Bulletin No.: PIT6144A
Published date: 06/21/2024

PIT6144A Diagnostic Tip for Service Leveling System Message And DTC: C1197

Example of twisted hoses on the 2024 Hummer EV SUV

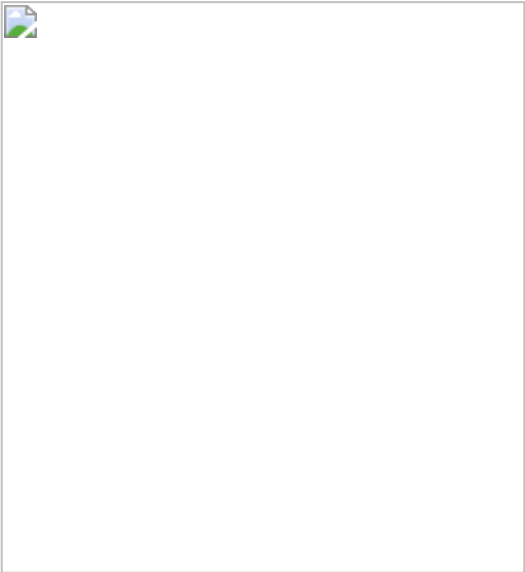
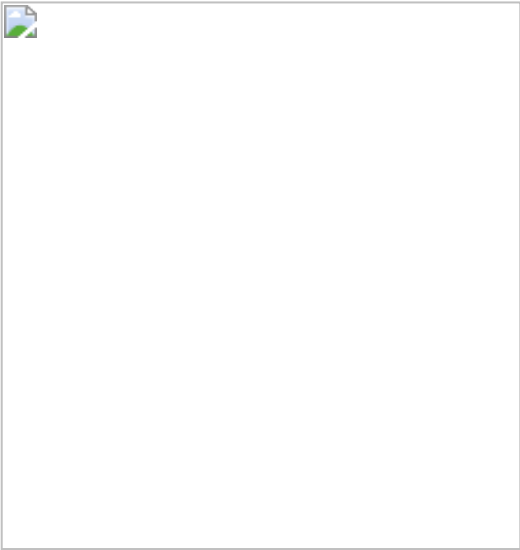
Inspect the air suspension compressor air inlet hose for being pinched or twisted and preventing air from entering the air suspension compressor. The air inlet hose assembly is shown as #17 below. If you find the air inlet hose pinched or twisted, repair as needed.

Example of a pinched hose on a 2023 Cadillac Escalade below:

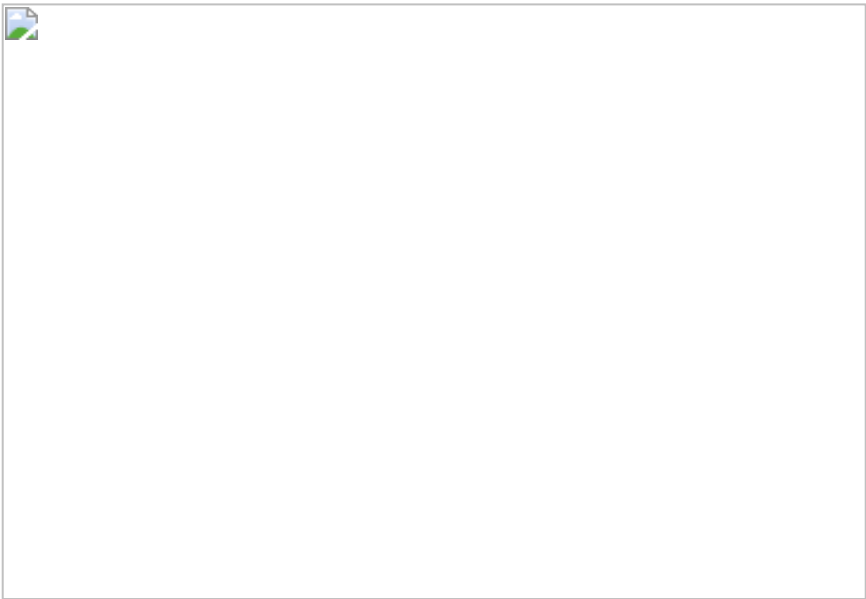
The 2024 Hummer EV Pickup may have an kinked hose due to a air inlet hose fastener that is located in a incorrect mounting hole that restricts the air inlet hose. See Below:

Locate the air suspension line assembly bracket in the right rear of the vehicle and make sure the air inlet line retainer is attached to the bracket as shown above in the locator hole marked by # 2.

If the hose retainer is in location #1, it will restrict the air inlet hose and you will need to remove the retainer clip and install it in location #2.
